May 24, 2017

**Re: Addendum to Geotechnical Engineering Report
Proposed Science Center - Santa Ana College
1530 West 17th Street
Santa Ana, California
Terracon Project No. 60145101**

Figure IS-2 Recommended design curves for selecting p-multipliers (P_m) as a function of normalized pile spacing for 1st row piles, 2nd row piles and 3rd row or higher row piles.

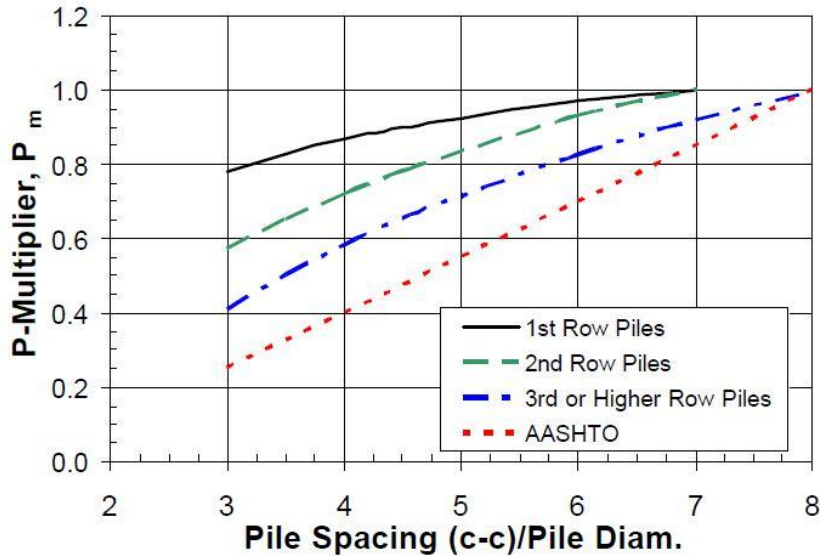
As for lateral capacity of group piles, group efficiency factor for lateral loading may be determined using the following chart included in the published study "Response, Analysis, and Design of Pile Groups Subjected to Static & Dynamic lateral Load", June 2003, Report No. UT03.03.
